1984 Corvette: Service Bulletin: Rack / Pinion Power Steering Valve Ring Service

Subject: RACK/PINION POWER STEERING VALVE RING SERVICE

Model and Year: 1981-84 CHEVETTE, 1982-84 CAVALIER,

Bulletin Number: 84-74 - (06/02/1984)

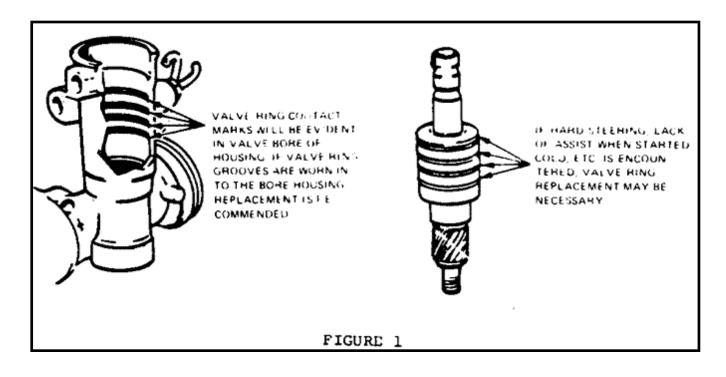
The design intent is that valve rings will remain stationary in the bore of a power rack and pinion assembly. If hard steering, lack of assist when started cold, etc., is encountered with normal pump pressure, inspect the rack and pinion housing valve bore (see illustration).

Ring contact marks in the valve bore is normal. If ring groove wear exists, replacement of the housing is necessary to assure that replacement rings will not eventually wear further into the housing and result in a recurrence of a lack of power assist symptom.

If only one (1) or two (2) of the four (4) ring contact marks in the housing have resulted in ring groove wear, the corresponding ring land of the valve is most likely causing excessive ring drag. Replacement of the valve as well as the housing would then be required.

In mid-1984, the rack and pinion housing valve bore will have a textured finish to further insure valve ring retention to the bore. The textured area in

the bore will be the circular band sealing ring surface corresponding to the four (4) rings in the valve body.

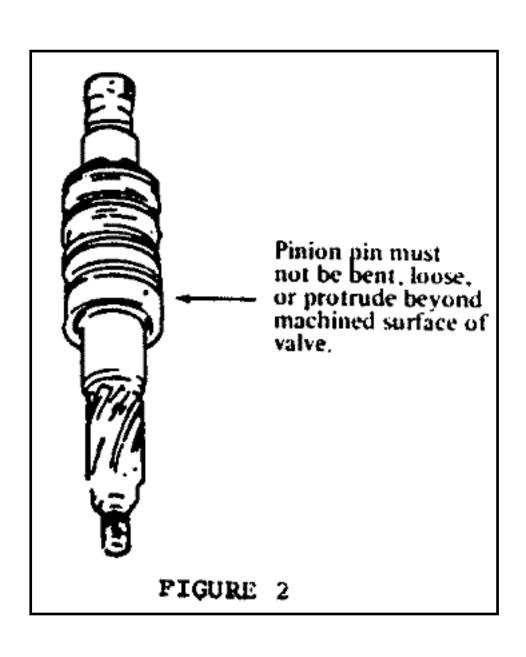
The valve and pinion assembly must be pressed out of the housing per Chassis Service Manual procedure. Excessive force or hammer use will likely damage the valve or valve pinion pin. After valve removal, inspect the valve pinion pin for being loose, bent, or protruding beyond the valve machined surface (see illustration). If any of these conditions exist, valve body replacement is required.

A lack of power assist symptom may also be caused by leakage past the rack piston ring in the housing tube bore. Inspect the rack piston ring for damage or distortion. The piston ring to ring land side clearance should not exceed .008". Also inspect the housing tube bore for any nicks, scoring or other imperfection in the rack piston travel area.

Mid 1984 production will have an "O" ring under piston ring. PISTON RING

- 1 Remove rack from nousing
- 2. Remove piston ring and dispose
- 3 Fit tool J-29738 into housing Using rod approx 12" long, gently tap on rod until seal is removed
- 4 Dispose of old seal

- Install new piston ring on rack
- 2 Care should be taken not to cut ring at installation
- 3. Wrap card stock around end of rack and rack teeth
- Coat seal lip with power steering fluid slide seal with seal tip facing piston on to card stock, slide card and seal over rack teein
- 5. Remove card stock and bottom seal on rack piston
- 6 Coat lip of seal insert with power steering fluid and slide on rack with lip facing seal. Be sure insert is felly engaged with seal before installing rack in housing
- Coat seal completely with power steering fluid slide rack and seal in housing tap on rack with rubber mailet to seat seal

NOTICE: Seal must be fully seated in housing
